TECHNICAL INSTRUCTION

TI 100
Issue 1
June 2008
Page 1 of 4

NETWORK RAIL - SIGNAL ENGINEERING Use of LED Long Range and Medium Range Signal Heads for Flashing Aspects

Relevant Standard: Typical Circuits T28330, T28333

Diagram A – extract from T28333

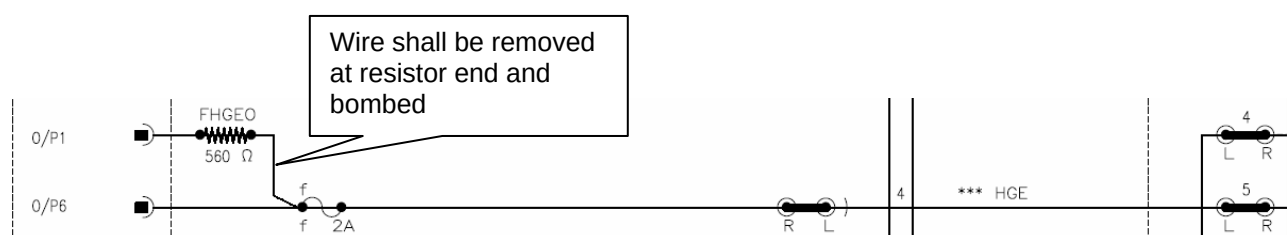
The wire from the FHGEO or FHHGEO to the fuse feeding the head should be removed and bombed, see diagram A.

Diagram B – extract from T28330

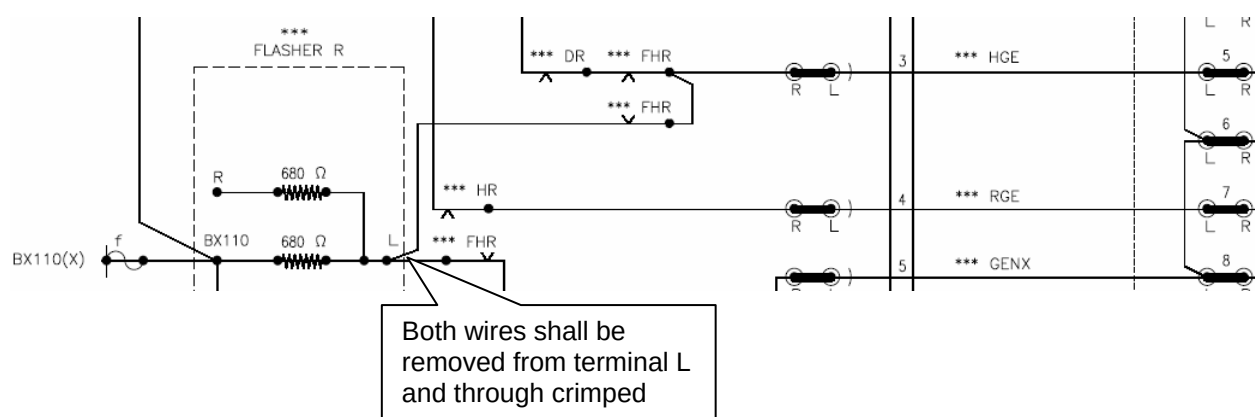
The two wires should be removed from terminal L of the flasher unit and through crimped, see diagram B.

A suitable label must be attached adjacent to the through crimp stating "Wires disconnected from flasher in accordance with TI100".
